**DOCUMENT 00 90 00**  
**ADDENDUM**

**ADDENDUM NO. [2]                      Date: March 21, 2018**

**RE:                      EAU CLAIRE AREA SCHOOL DISTRICT  
McKINLEY CHARTER SCHOOL  
1266 McKINLEY RD  
EAU CLAIRE, WISCONSIN 54701  
HSR PROJECT NO. 17057**

**FROM:                  HSR Associates, Inc  
100 Milwaukee Street  
La Crosse, WI 54603  
(608) 784-1830**

E101R1

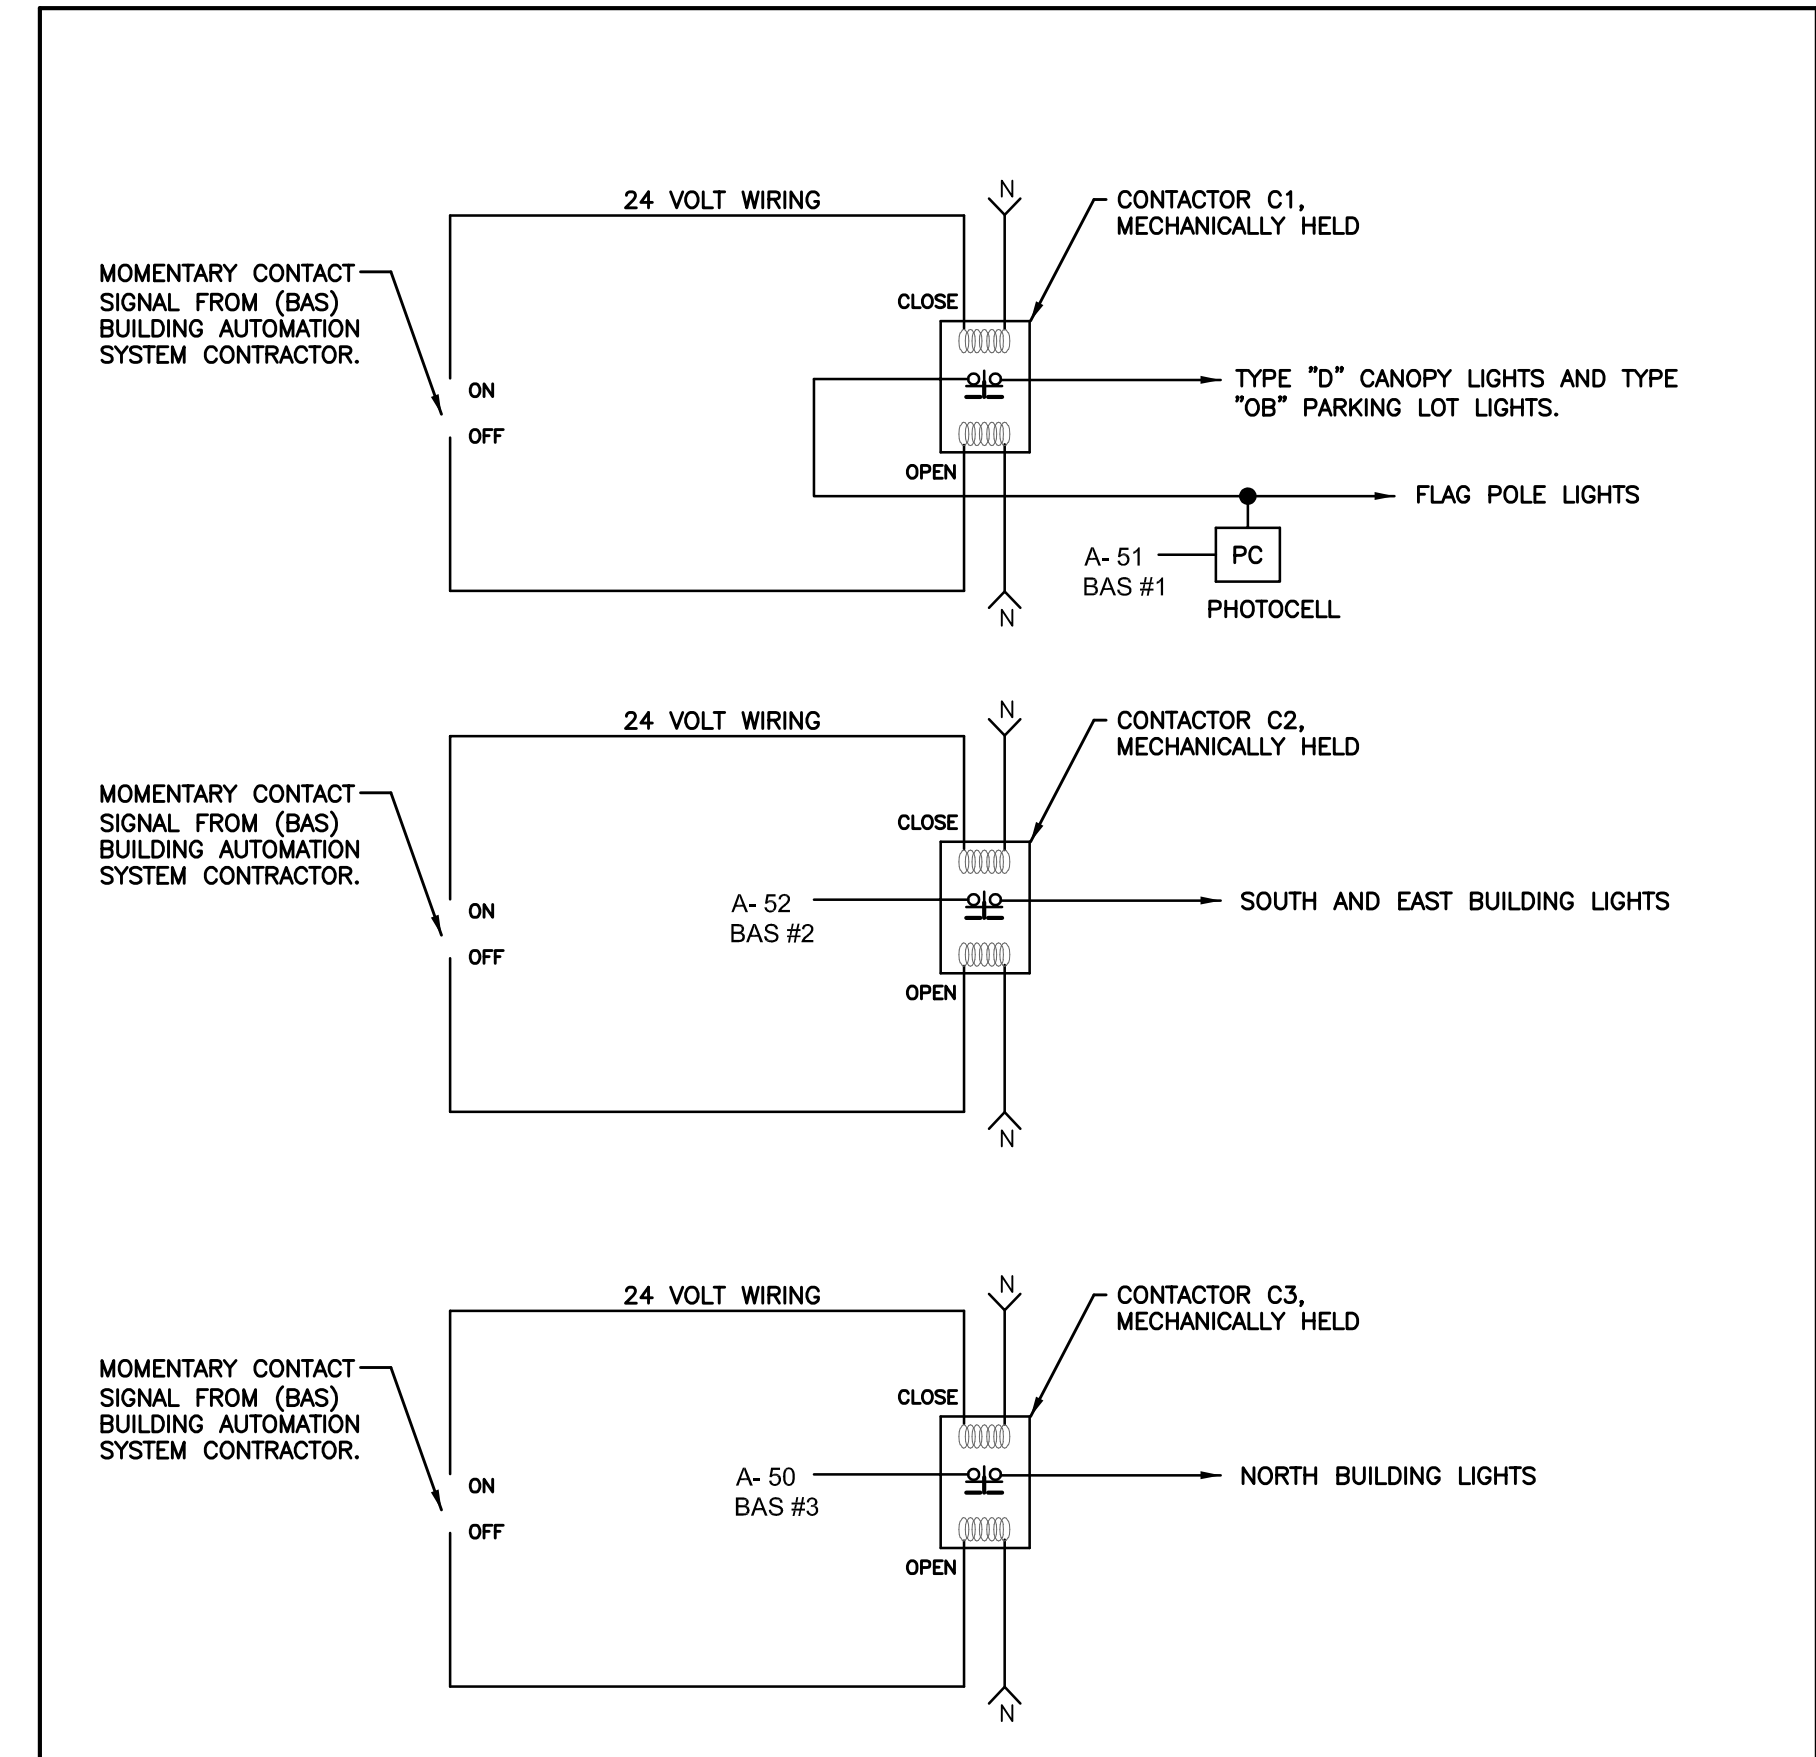
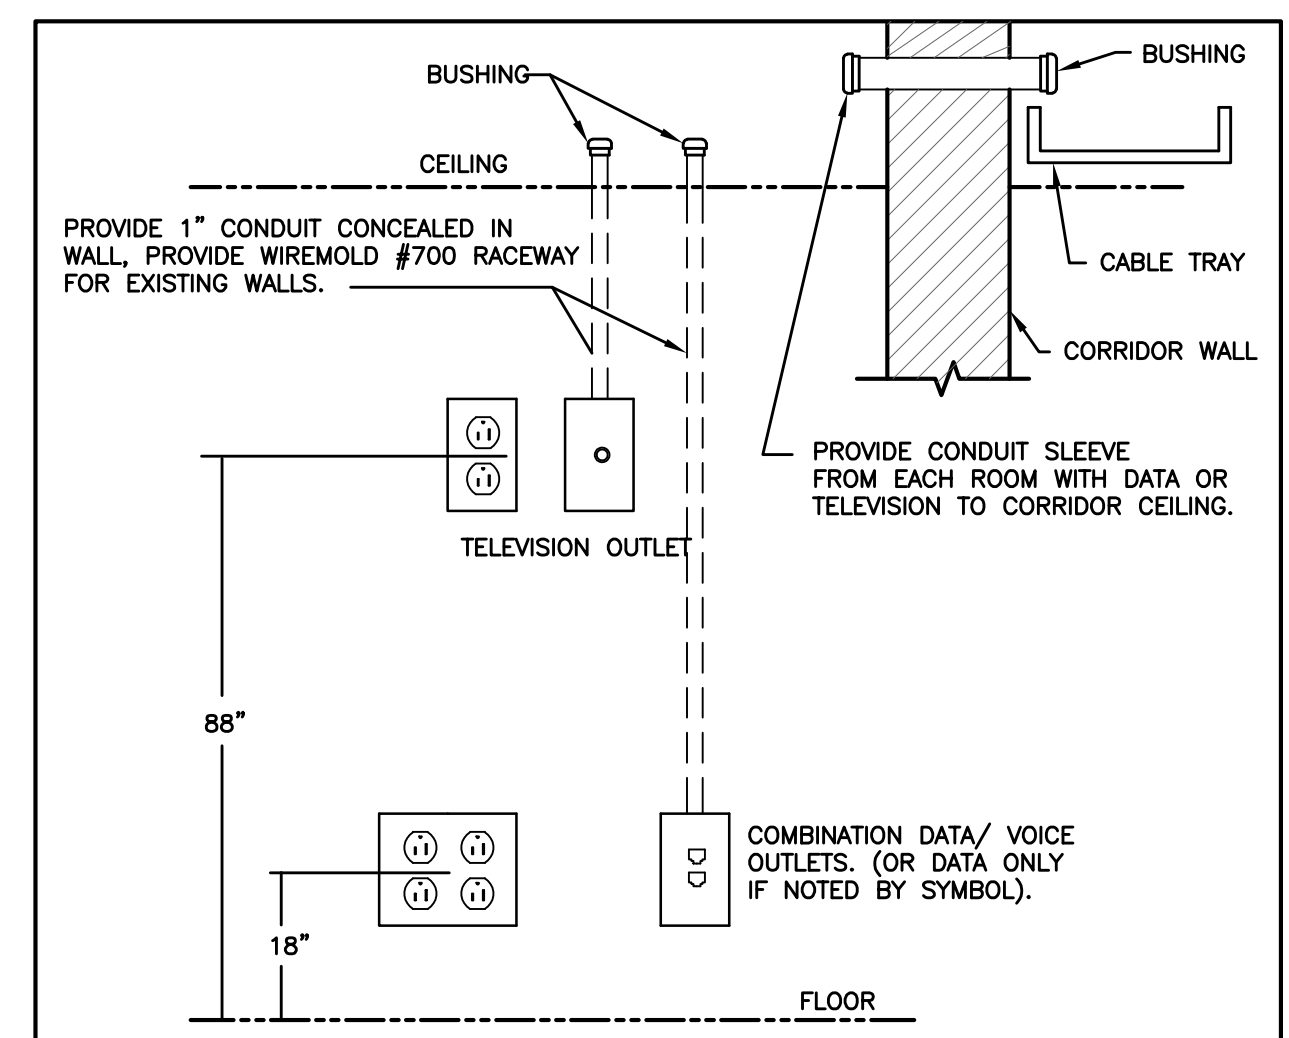
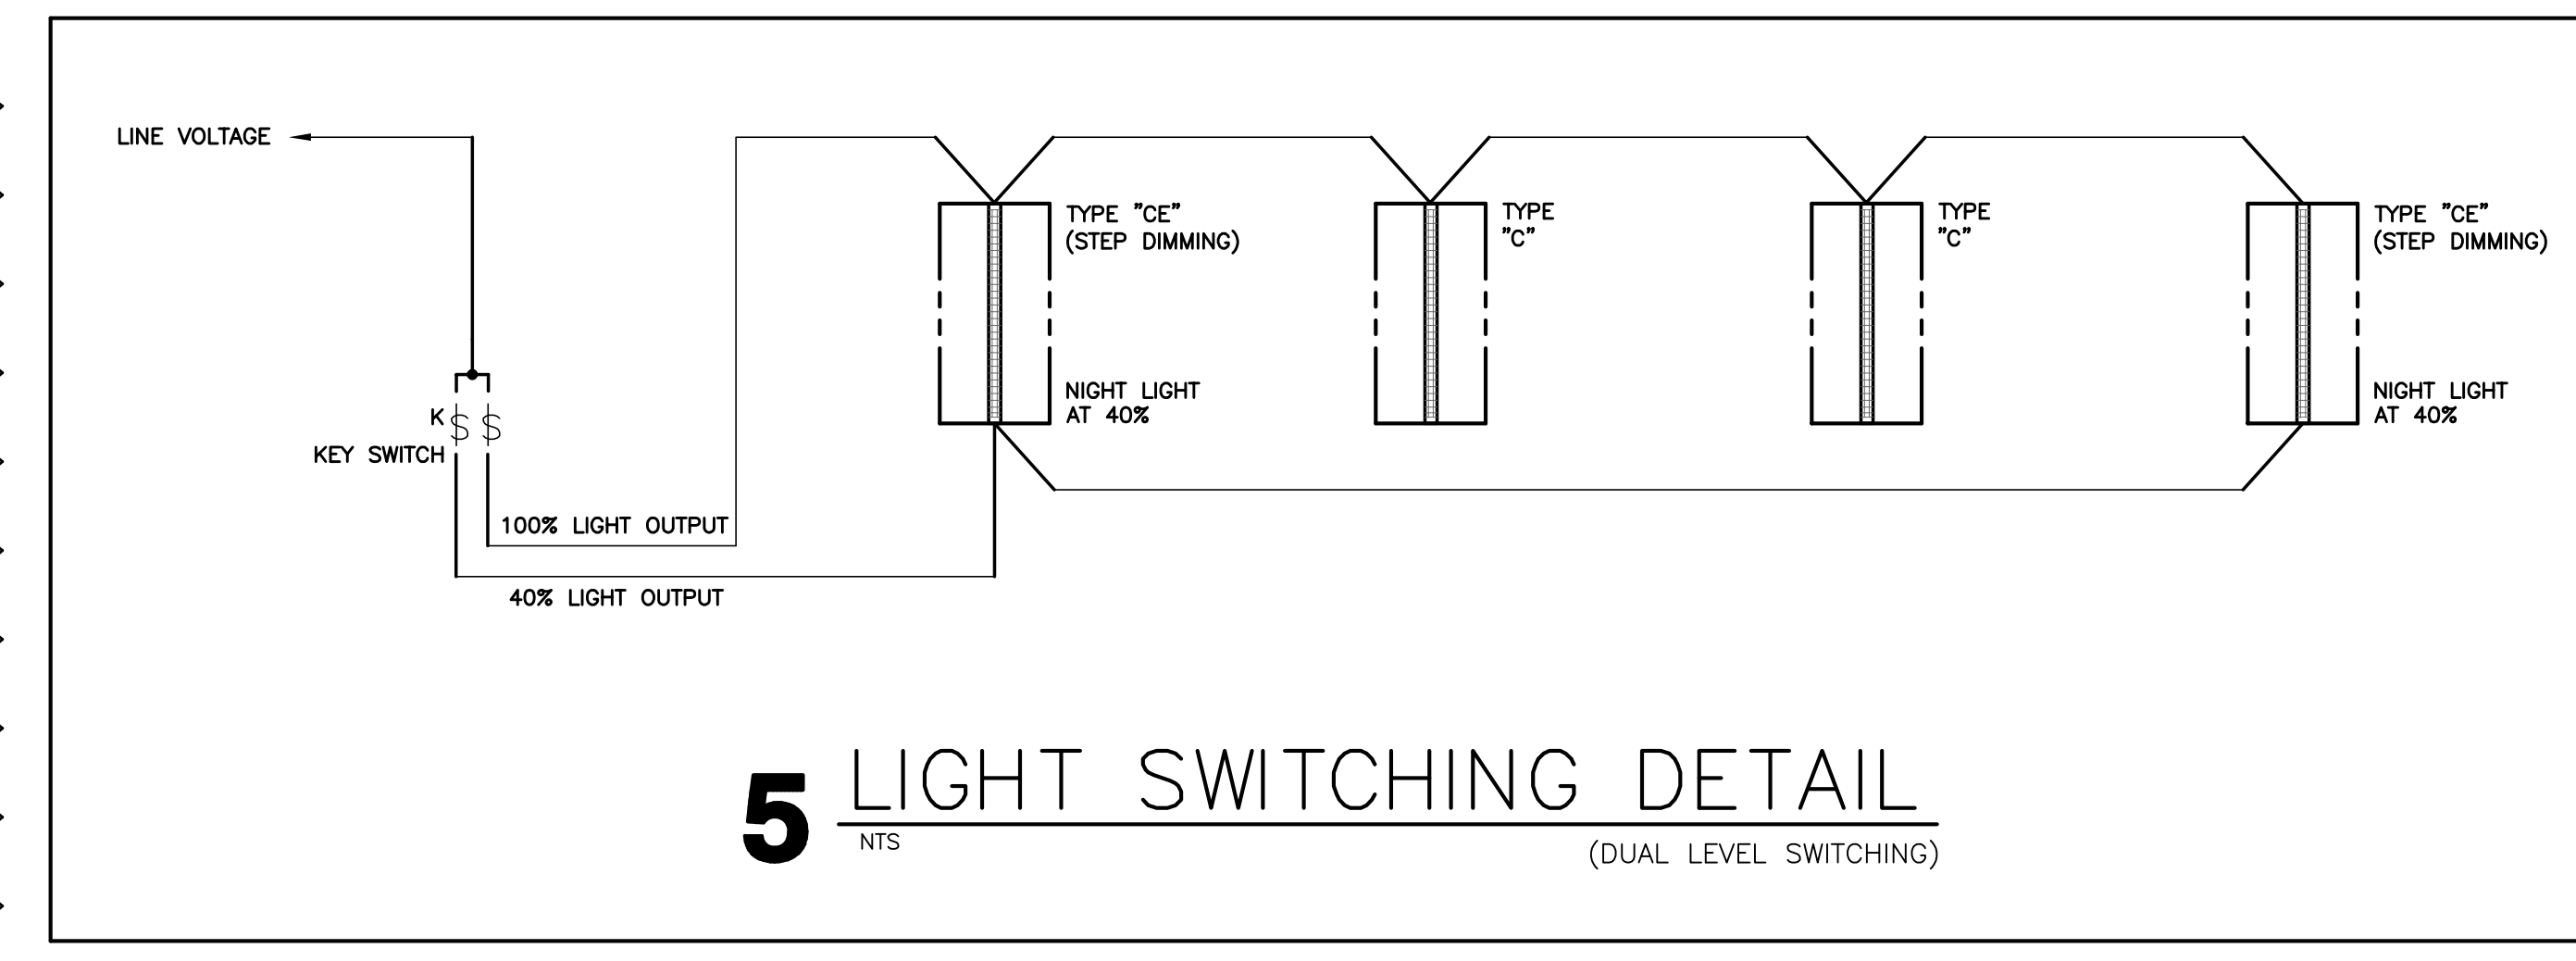
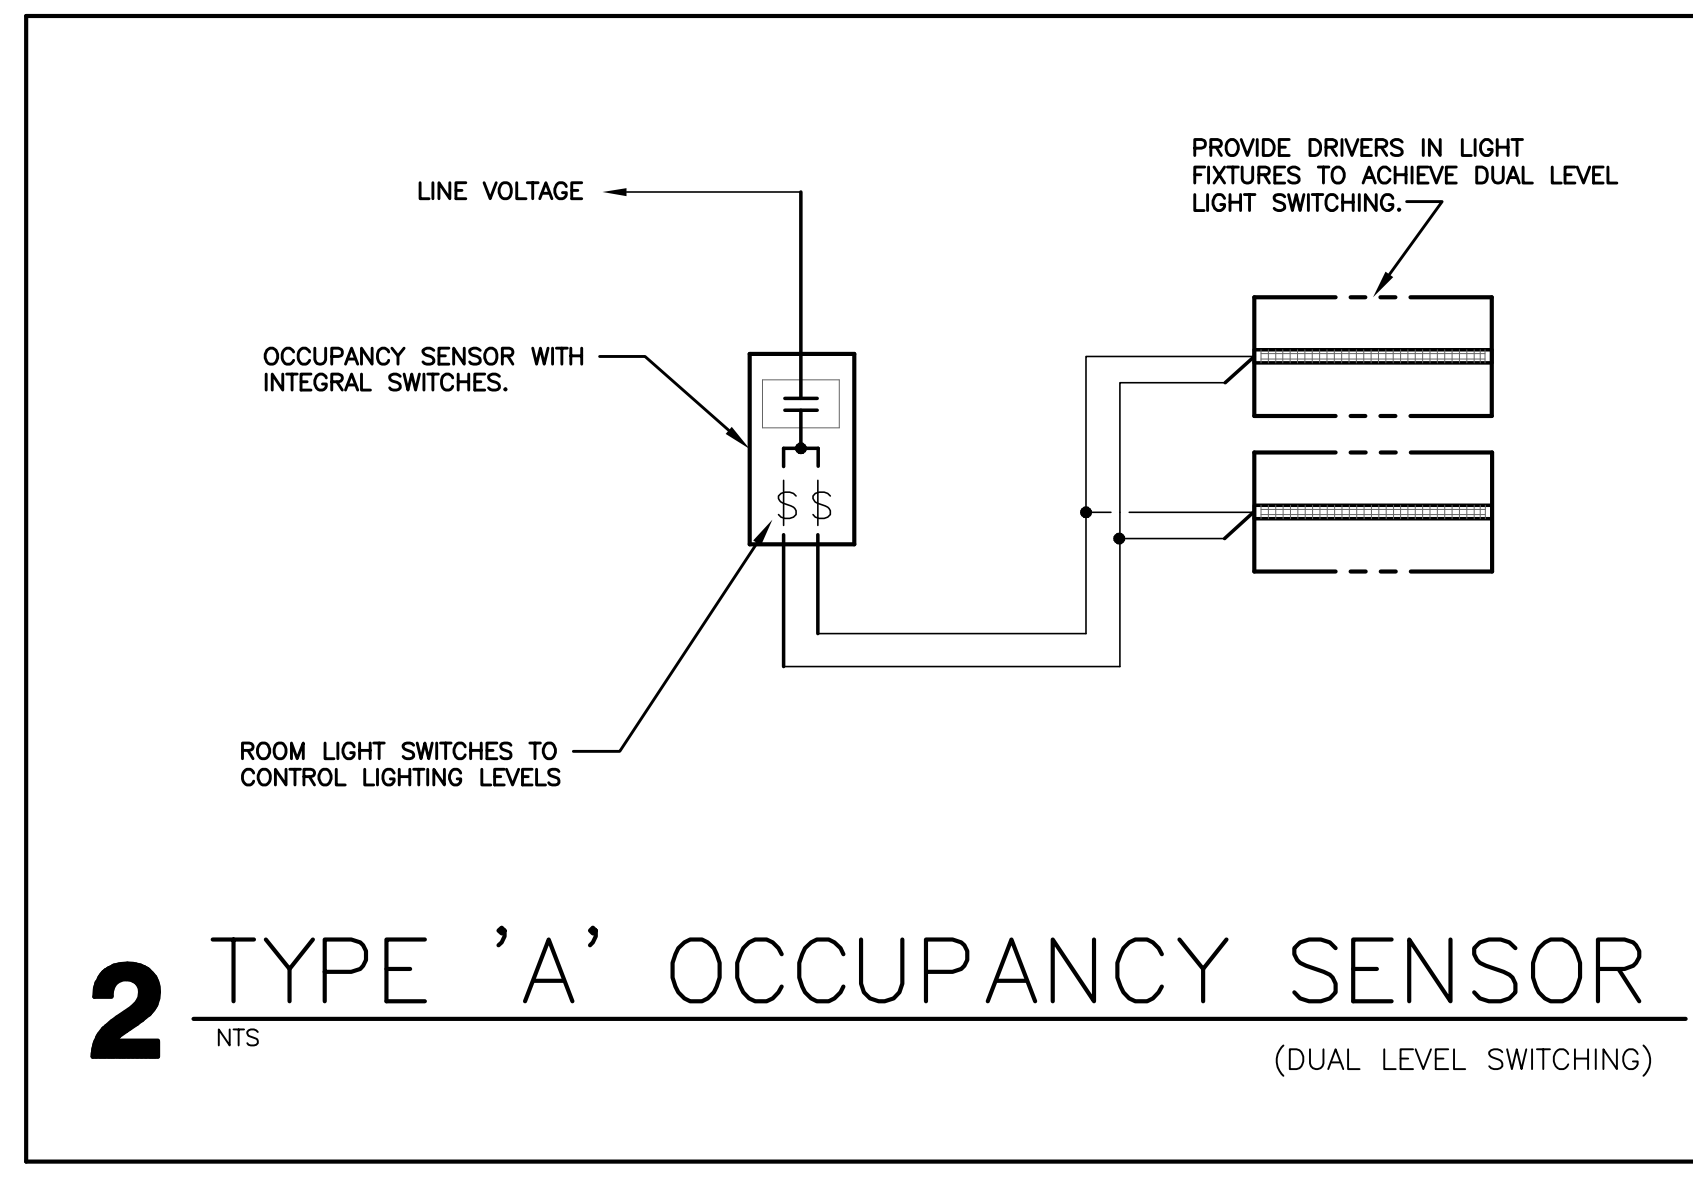
14. Sheet E101R1 REVISED LIGHTING PLAN 30 x 42 attached hereto
  - a. Revisions clouded on Drawing.
